Staff Report for Item 3

Application Number: H15-01-1665

Address: #702 Pearl Street

Partial demolition of side and rear additions with no build back.

PROPOSED PLANS

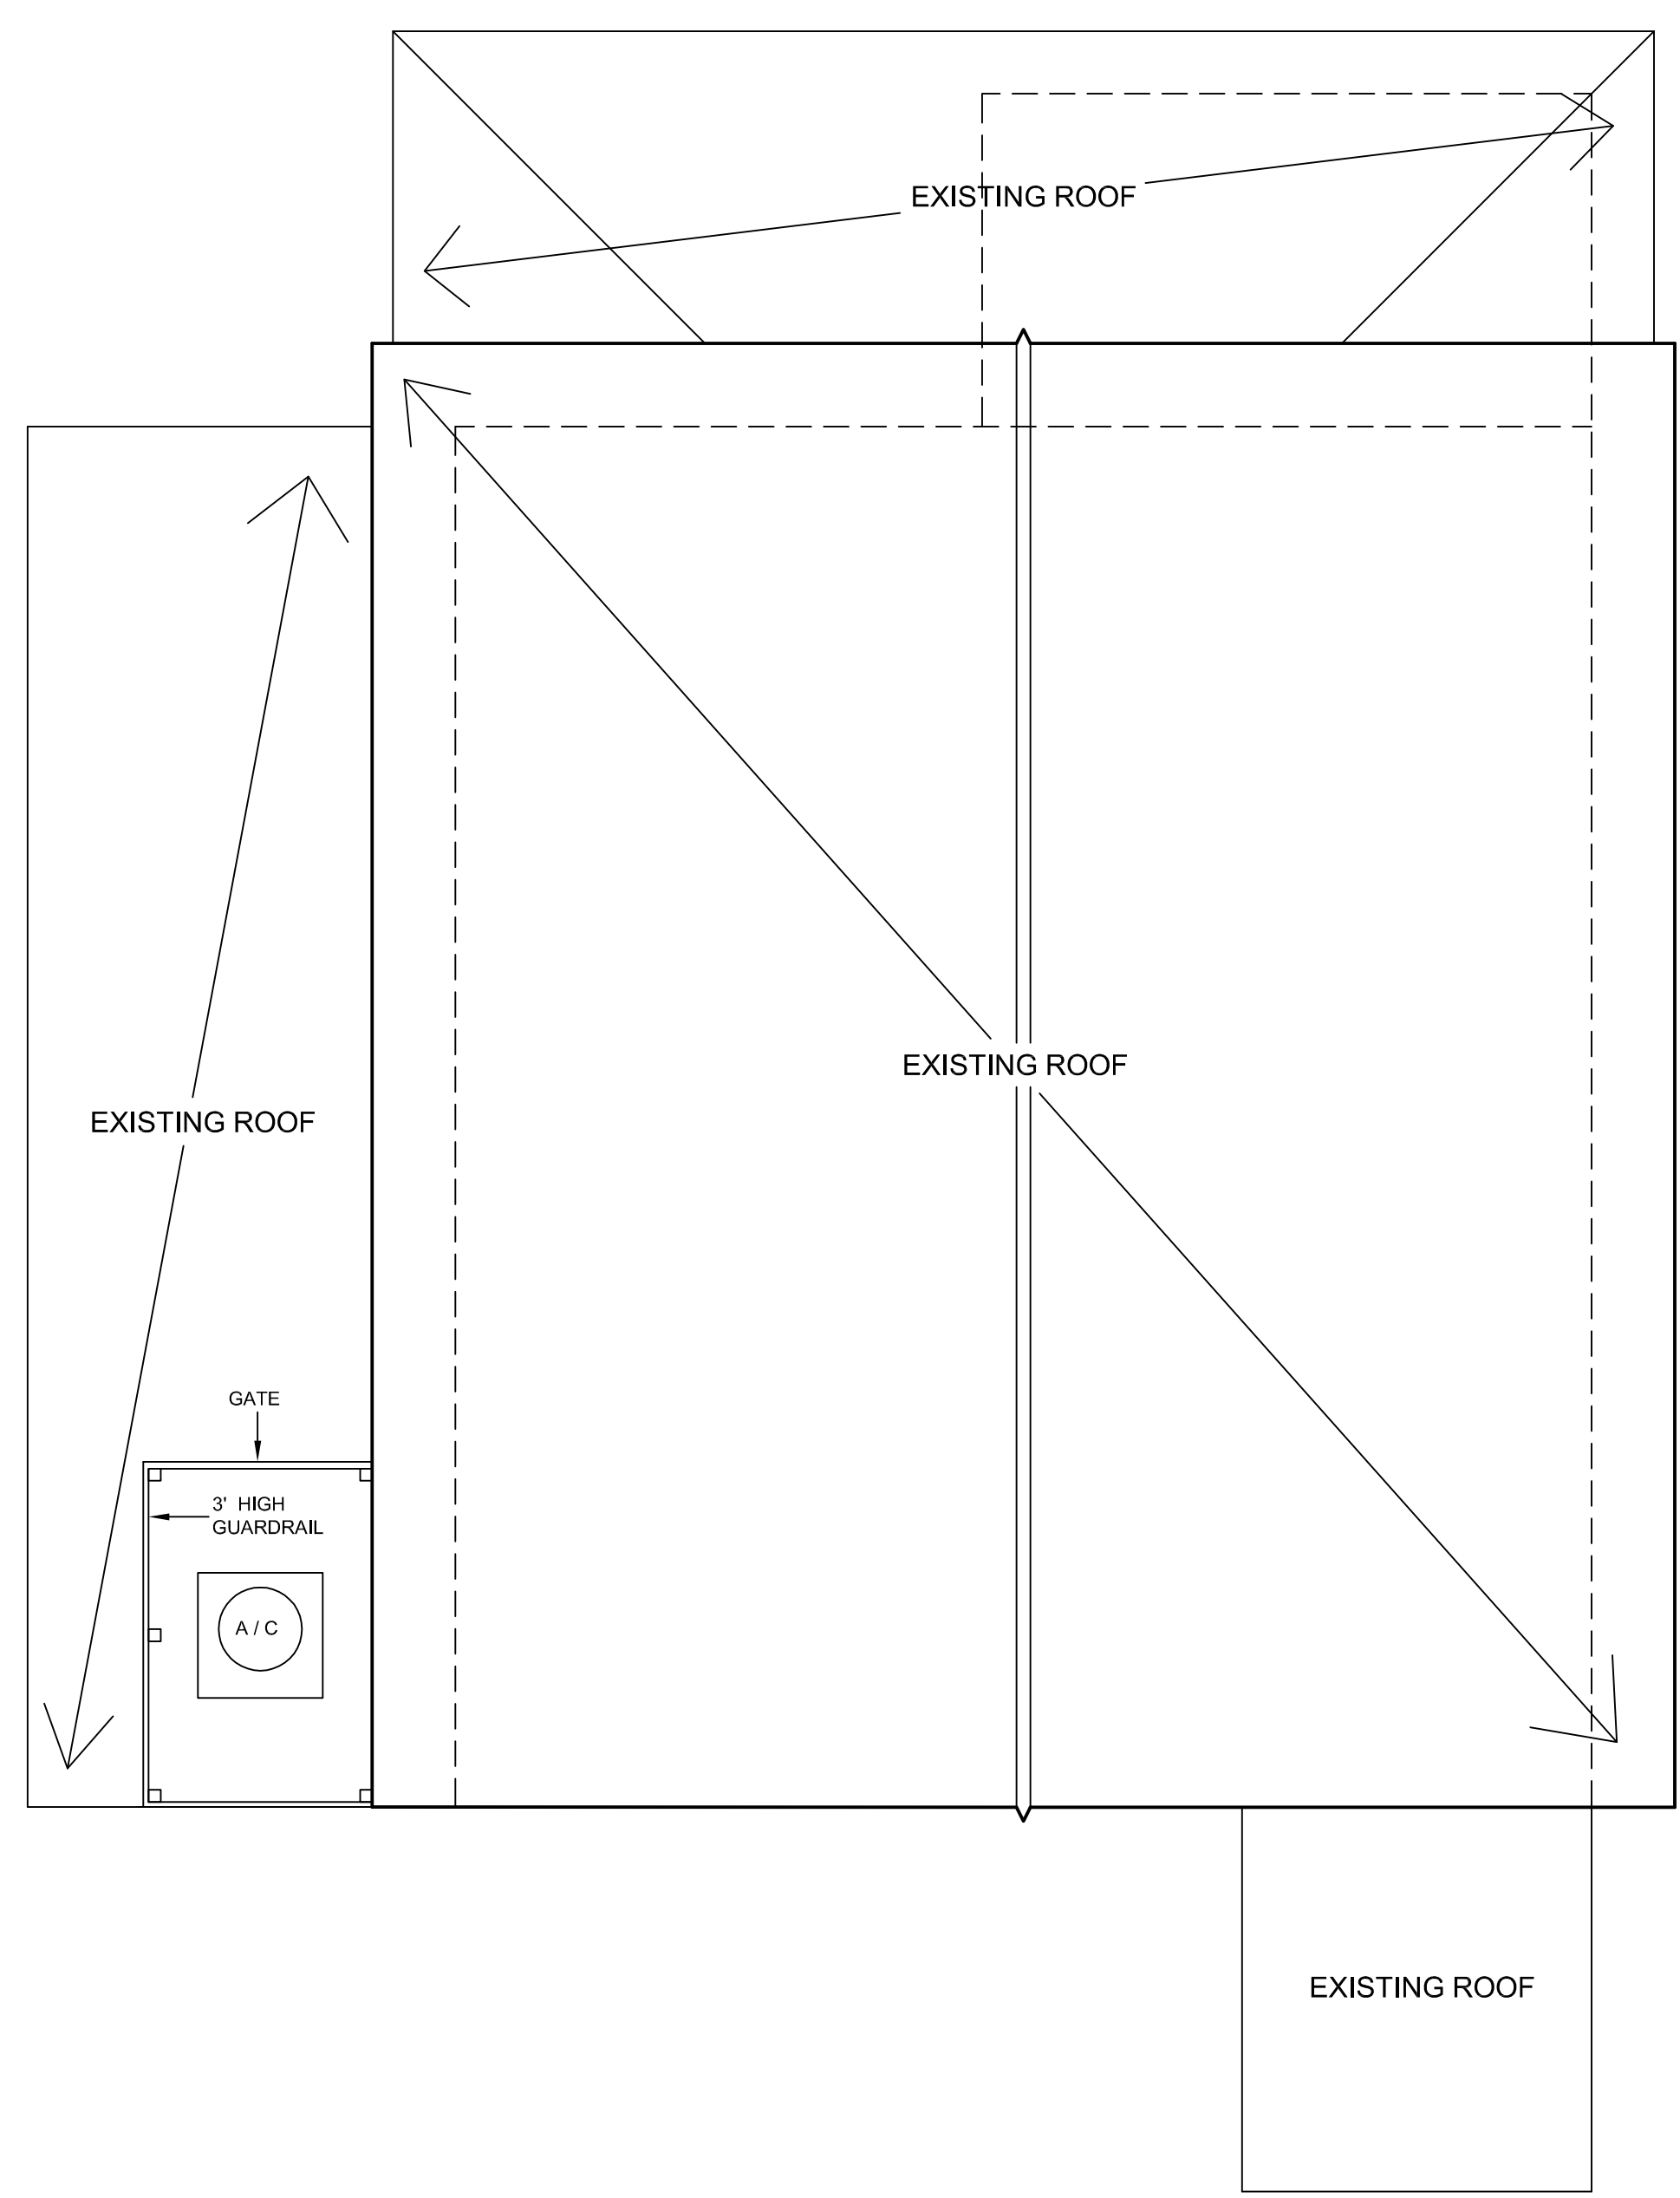
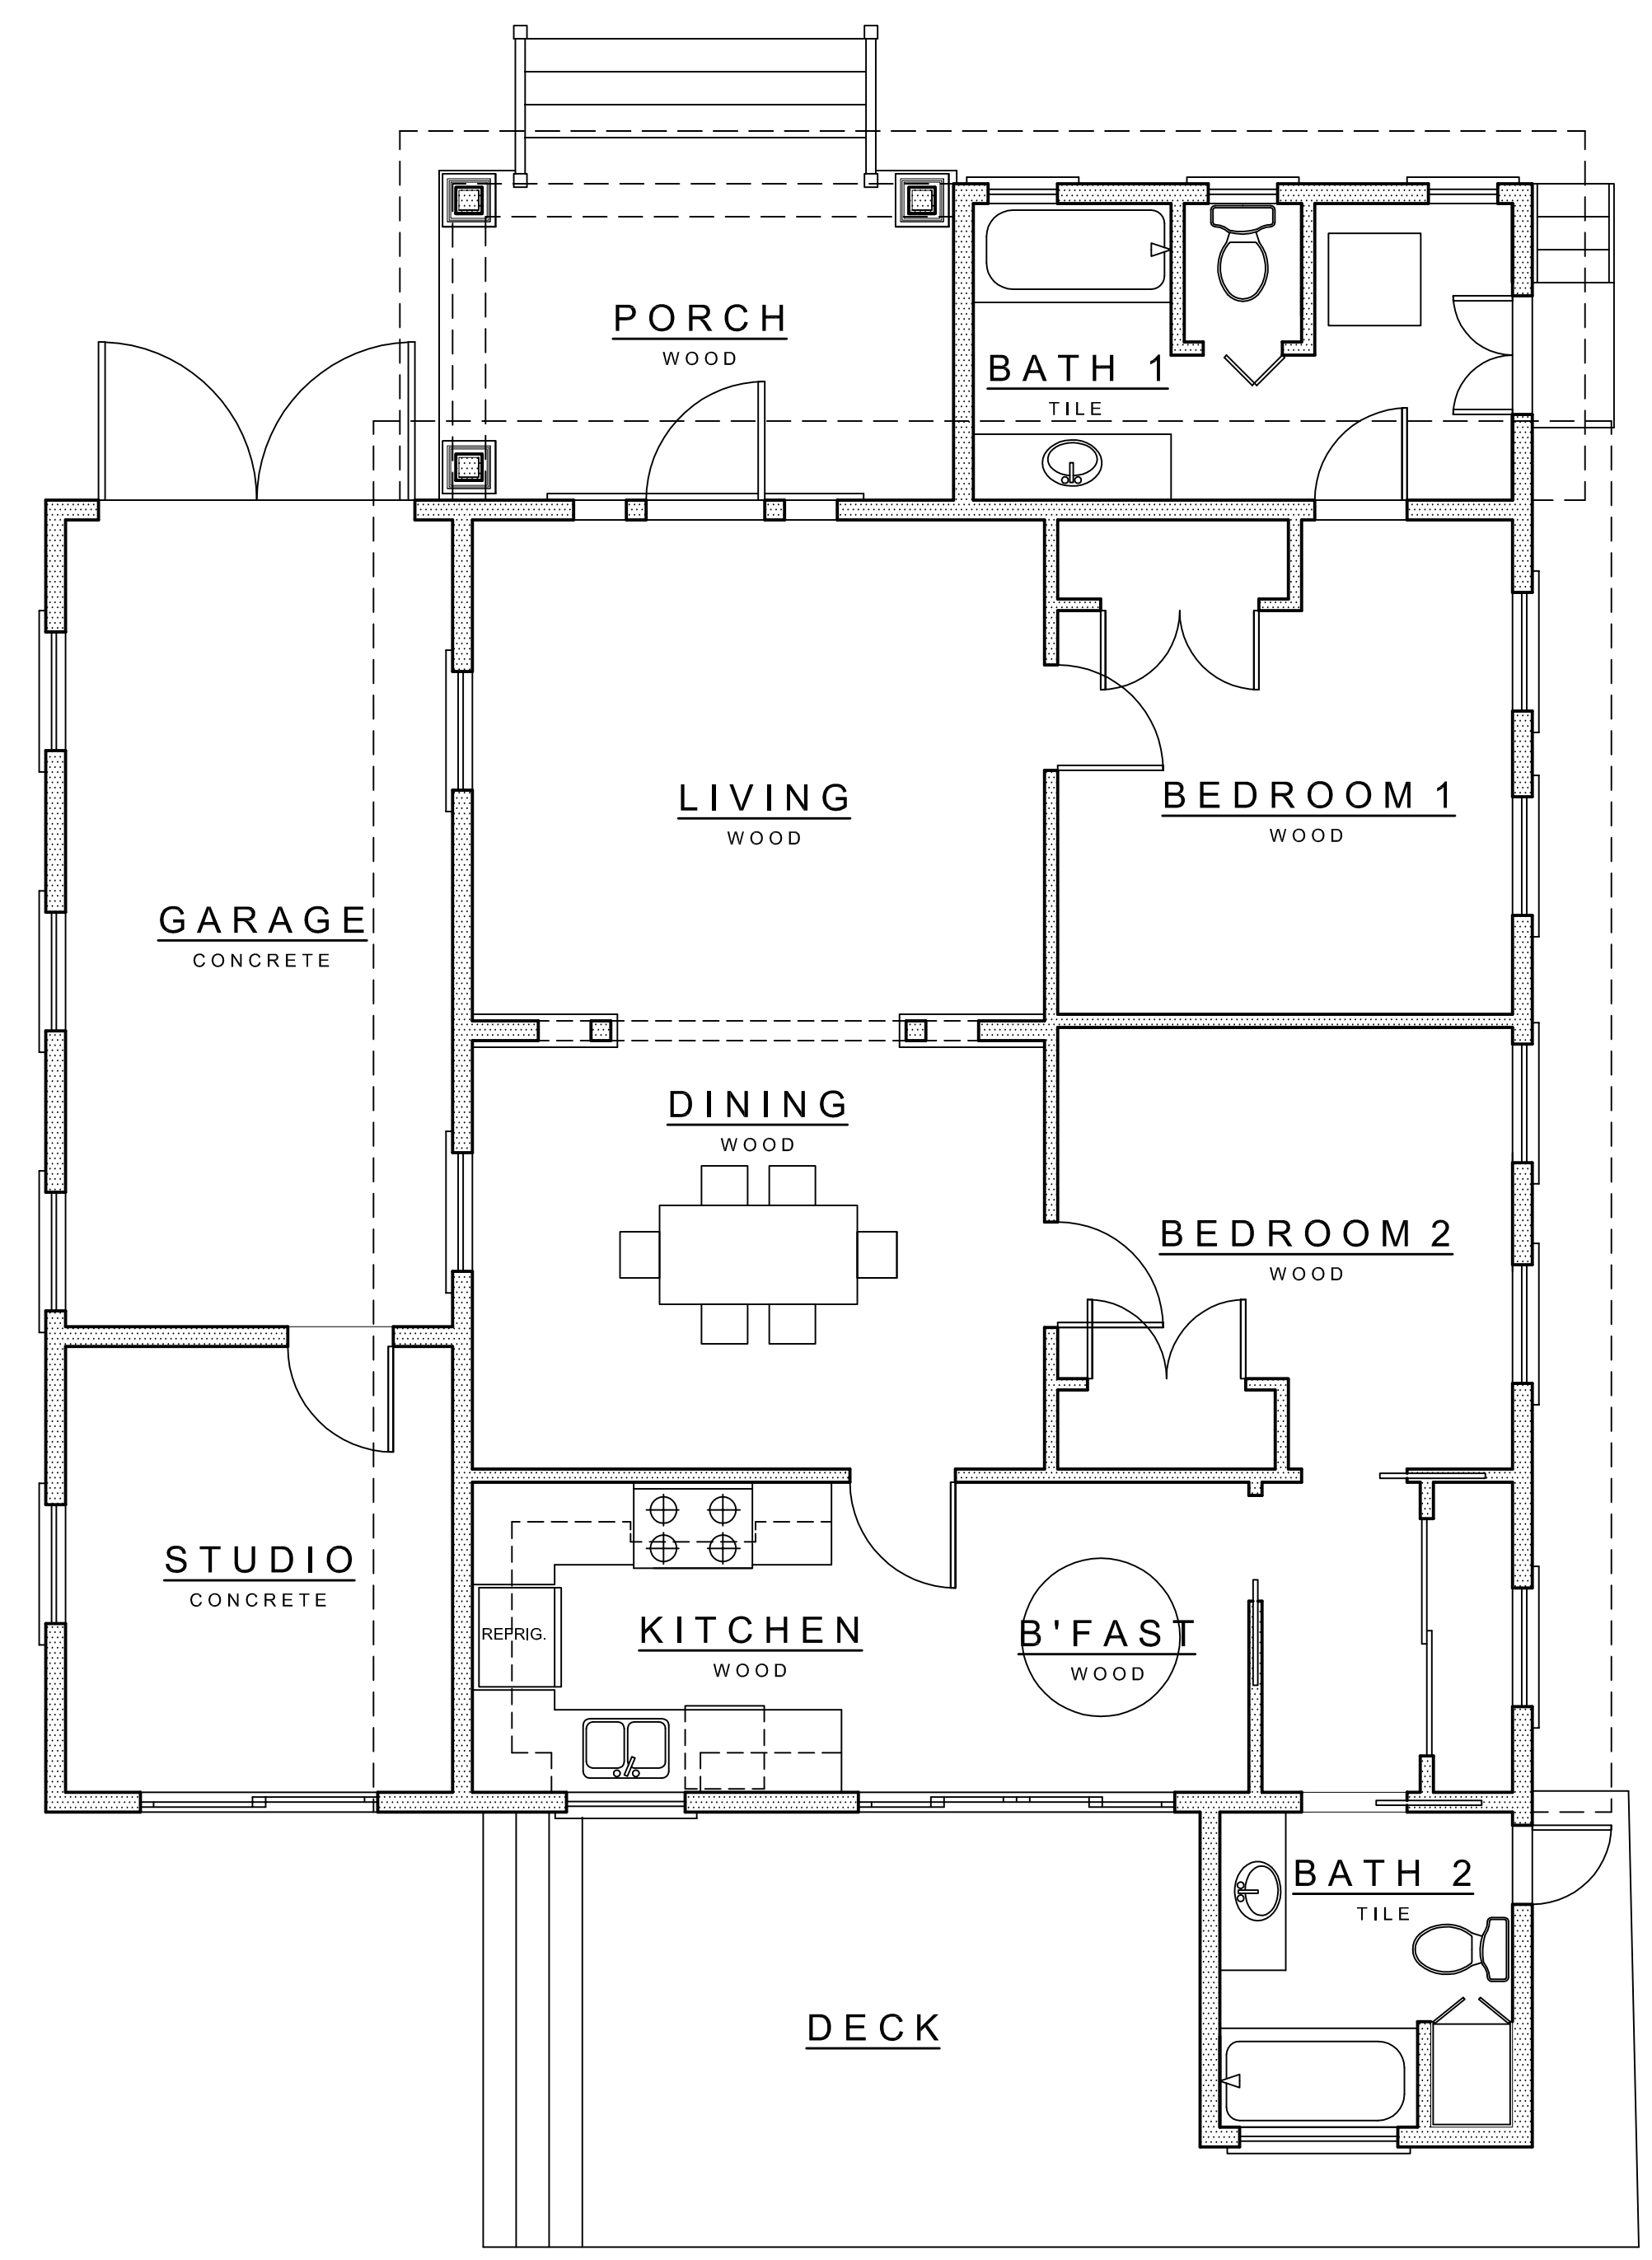
When speaking with Kelly recently about your issue concerning the condenser location, I told her that I would speak with the owner about the matter. I have spoken with them and we thoroughly discussed all the options we were able to conceive of regarding alternate locations of this equipment to the current location on the rear of the garage roof as shown in my drawings.

Because the lot is substandard, the building drastically crowds the rear property line and leaves very little area for outdoor activities and foliage. That and the condition by Planning that such equipment cannot be any closer to the side and rear property lines than 5'-0" leaves no real desirable alternative. I would ask you to look closely at the drawings to verify these conditions.

Furthermore, I am convinced that the proposed location on the garage roof, well outside the side yard building setback line and at the extreme rear of garage would render the equipment not viewable from the street. A visit to the site would verify this. The height at the lowest end of the roof is 9'-6" and it slopes to higher at the house.

As mentioned in the staff report given the 5 foot setback requirement for AC units it is clear that an alternative location on the ground could be considered. If the re-design moves the railings out of the setback and the proposed second story is not in the required side yard setback, planning staff has no issues. Please coordinate with HARC staff moving forward.
